2.0 REGULATORY AND ENVIRONMENTAL ASSESSMENTS

The City's current Closure/Post-Closure Care Plan for the landfill was reviewed. The plan was prepared by HDR Engineering (HDR) and is dated August 2001. The intent of the evaluation was to:

FIGURE 2-1
CLOSURE PHASING FOR ACTIVE AREA
 SOLID WASTE MASTER PLAN
 CITY OF SIOUX FALLS, SOUTH DAKOTA
 OCTOBER 2003 SIOUX FALLS REGIONAL LANDFILL 63063

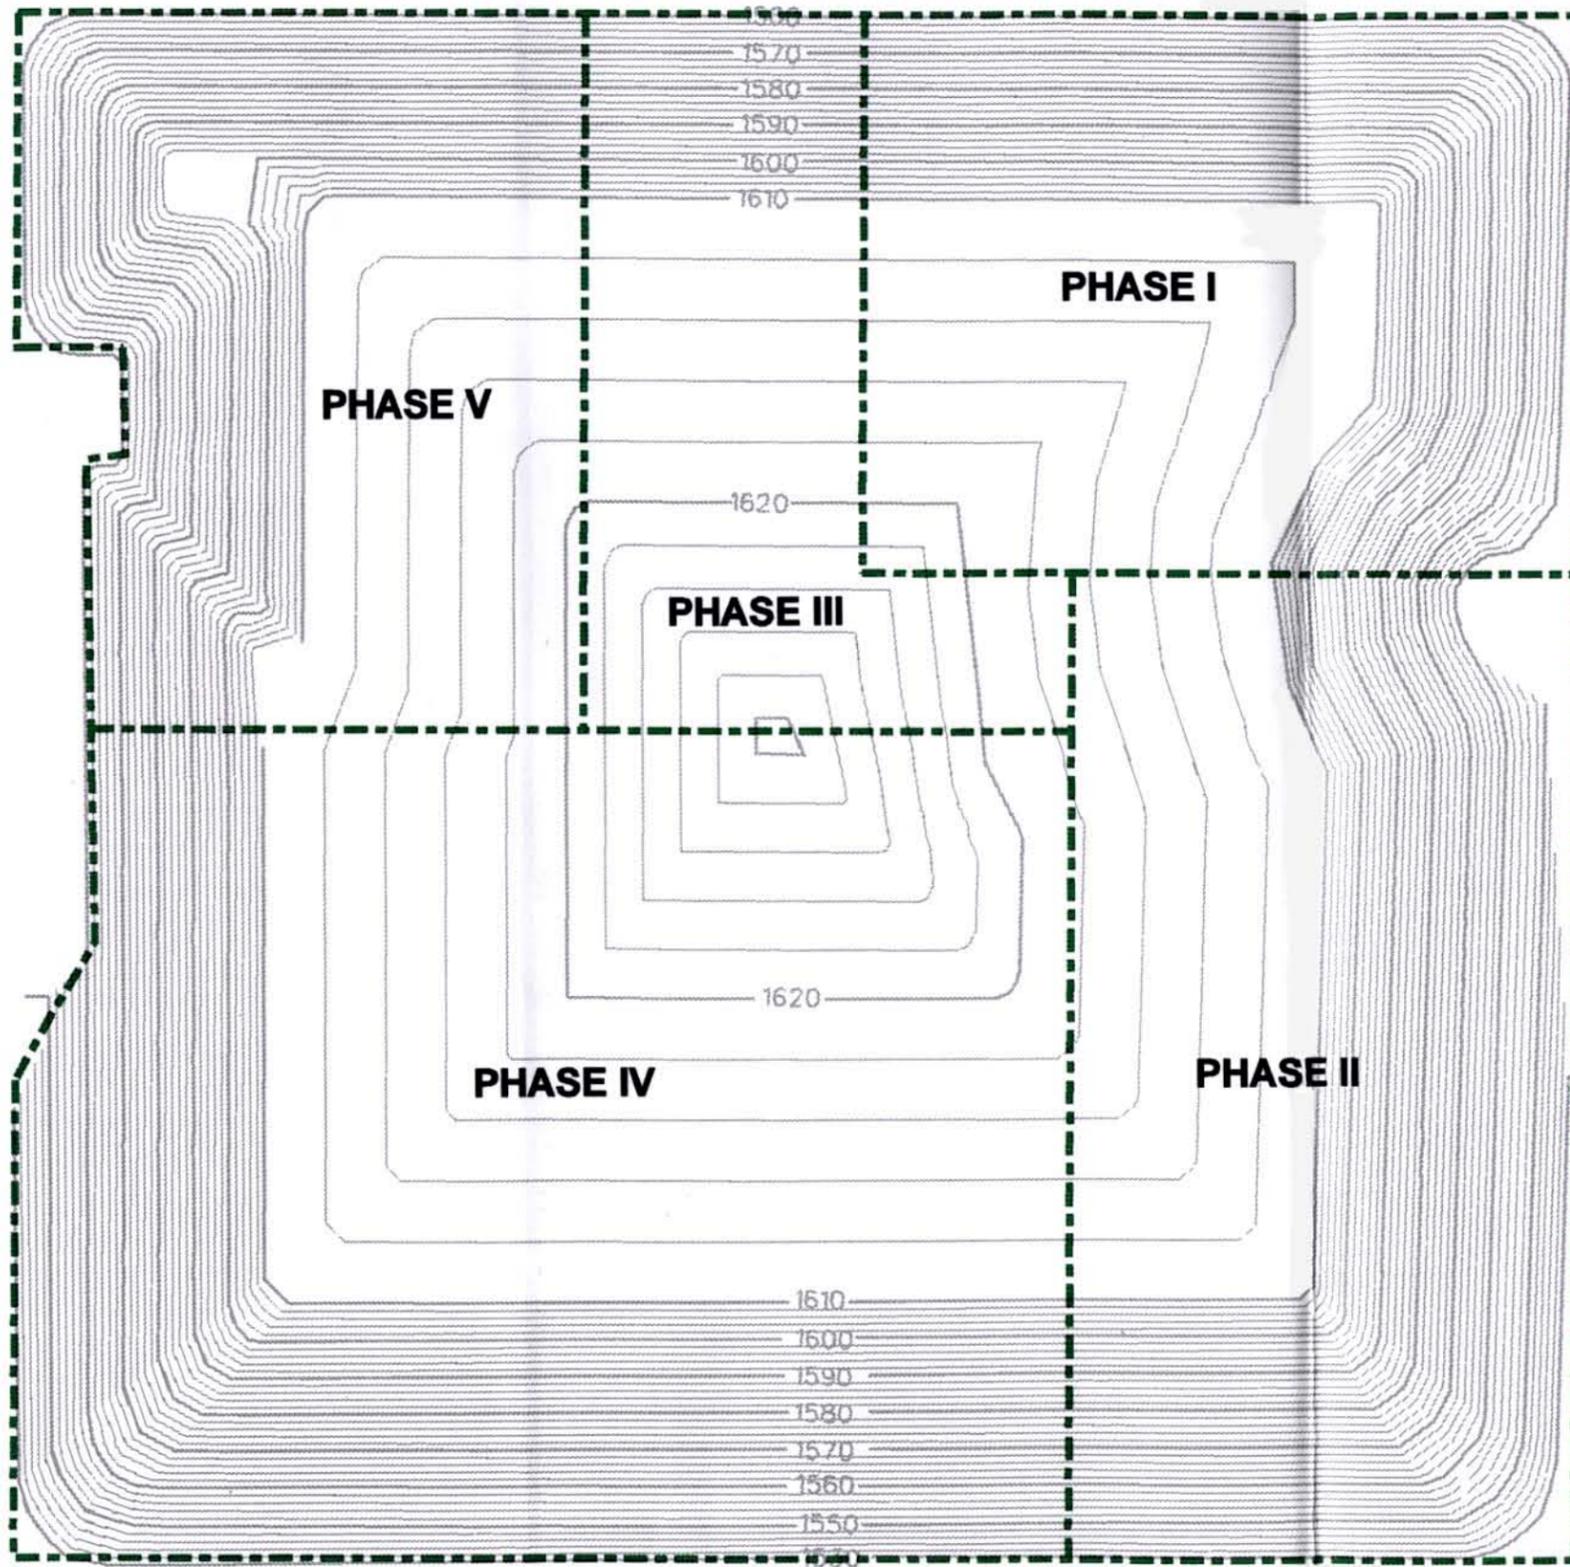
The proposed closure phases for the Active Area are shown on Figure 2-1, included at the end of this section. The areas of the phases are approximations. Closure of Phases I, II, and III generally reflect HDR's Plan. For the remaining portion of the Active Area, we recommend that sequencing of closure and the areas of the closure be modified from the Plan as indicated on Figure 2-1. Phase IV includes the C&D area that is currently under development. As outlined in Section 3.0, Operational Assessment and Issues, we recommend that the compost site be moved from this area. This will allow continuous development of the existing C&D pit, which will maximize disposal capacity. During development of Phase IV, the Phase V area would have intermediate cover and could still be used for other site needs such as petroleum contaminated soils treatment, temporary storage of materials or stockpiles, continued use for asbestos disposal, and temporary placement of landfill gas collection infrastructure (it is expected that active gas extraction will also occur in the Emergency Cell).

During the process of developing this report, the City surveyed actual boundaries of waste within the Active Area. This survey is documented on an "activity map" that the City prepared July 18, 2003. The closure contours that were developed for the Plan (HDR, 2001b) were prepared without the benefit of this information.

The proposed waste boundary used in the Plan on the west side of the Active Area is highly irregular. This was presumably done during preparation of the existing Plan to avoid existing site structures and to maximize landfill capacity. In practice, construction of final slopes with sharp jogs is not recommended due to construction difficulty and the potential problems with long-term maintenance caused by channeling and erosion.

Future Plan revisions should take into account current topographic conditions, location of existing waste units, and placement of infrastructure (i.e., the proposed leachate loadout facility).

**FIGURE 2-2
CLOSURE PHASING
FOR EXPANSION AREA**

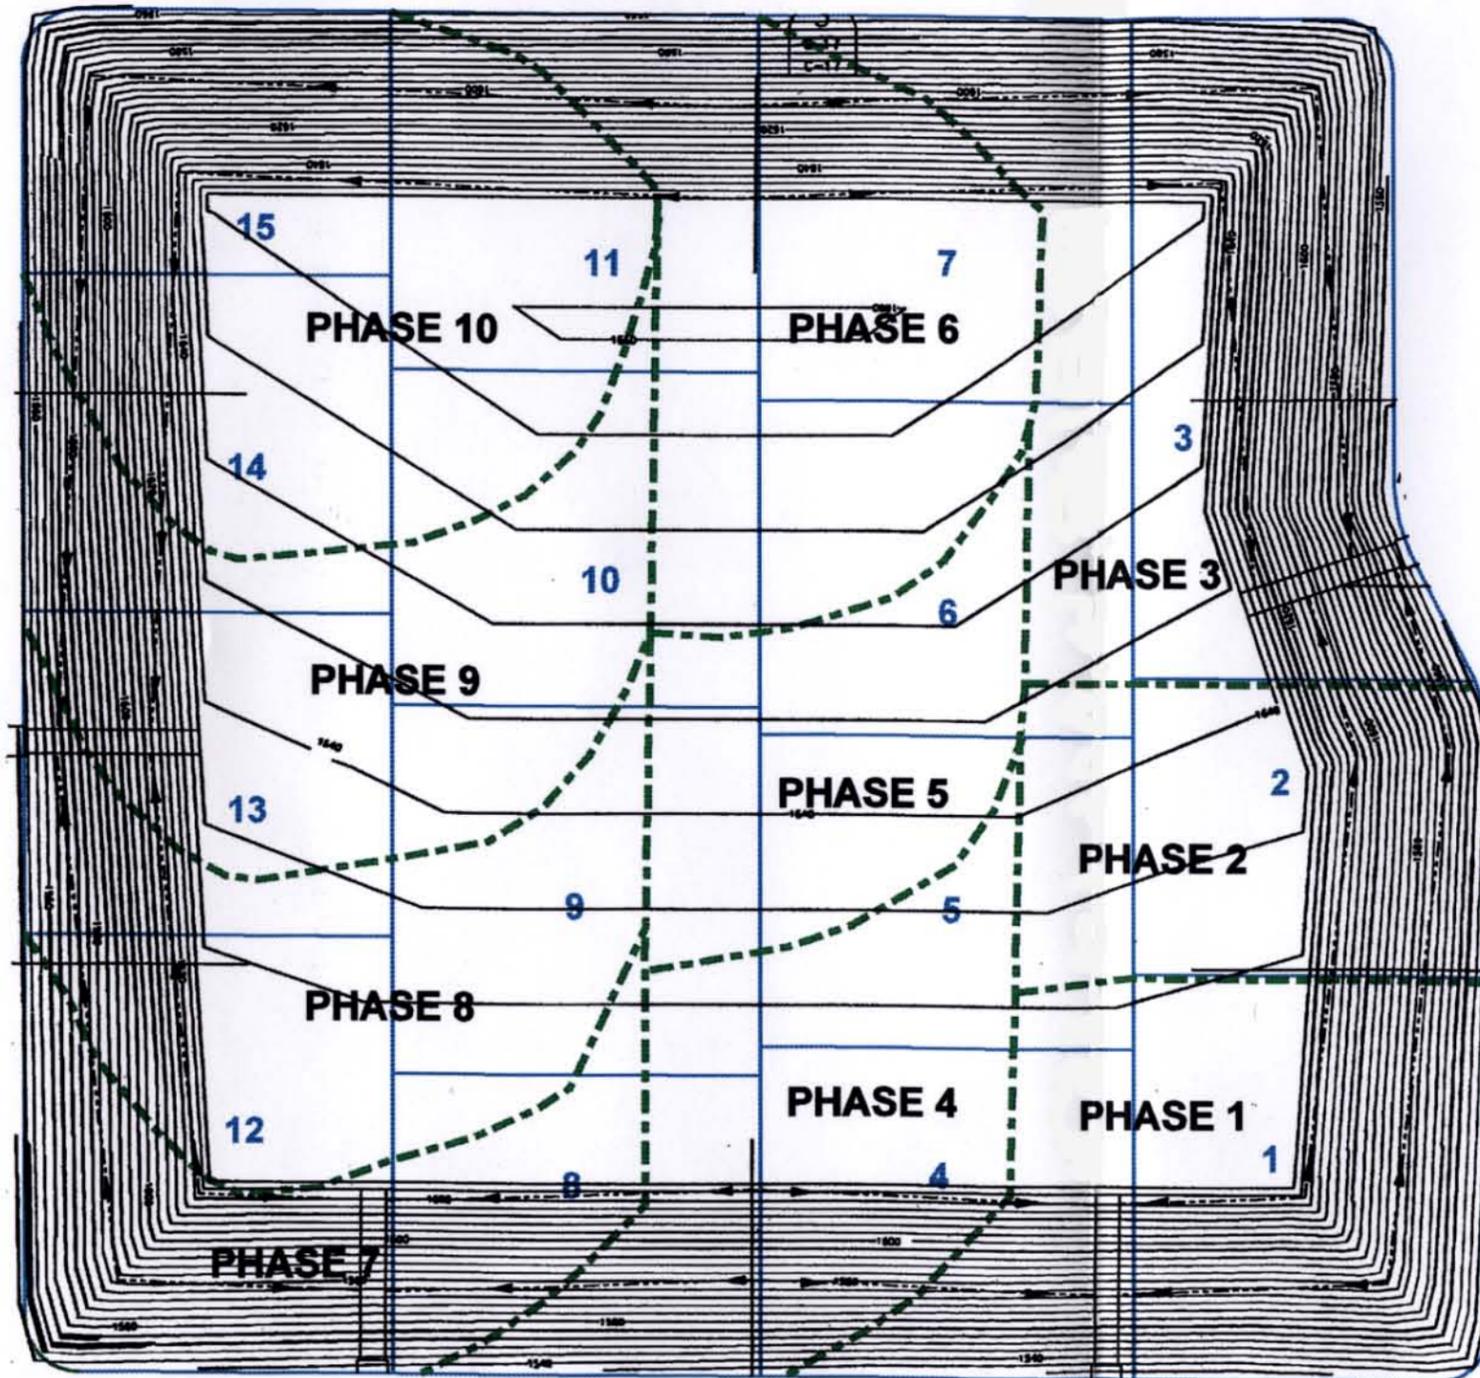
Although the Plan did not address closure of Expansion Area, a proposed schedule was included in the Leachate Management Plan (HDR, 2001c). That document proposed 12 closure phases over the 34-year landfill life. Based on our review of the development plans, we propose that the number of Phases be reduced from 12 to 10. This is intended to improve efficiency and control cost by enlarging some of the phases so that construction would occur in more reasonably sized areas. The proposed closure phases for the Expansion Area are shown on Figure 2-2, included at the end of this section. Note that construction of the first closure phase will not occur until the time that Cell 5 is active. From that time forward, with one exception (Phase 4), a closure phase is planned to occur at the time of development of each successive Cell.

Similar to the Active Area, the top slope on the Expansion Area is minimal. The development plan included in the 2001 permit application provides for a final top slope of 2.6 percent with a slope length of 1,080 feet. Also, a 300 foot portion of the top slope is only 1.3 percent. For reasons similar to those outlined above for the Active Area, we recommend that the design of the Expansion Area be modified to provide minimum slopes of 5 percent.

1. CLOSURE PLAN BASE MAP IS FROM "SIOUX FALLS REGIONAL LANDFILL LATERAL EXPANSION DISPOSAL AREA FILLING PLAN" (HDR, 2001). AREAS AND PROGRESSION OF PHASED CLOSURE HAVE BEEN MODIFIED PER RECOMMENDATIONS OF THE MASTER PLAN. THE ESTIMATED YEAR OF CLOSURE IS BASED ON SITE LIFE ESTIMATES CONTAINED IN THE HDR FILLING PLAN.
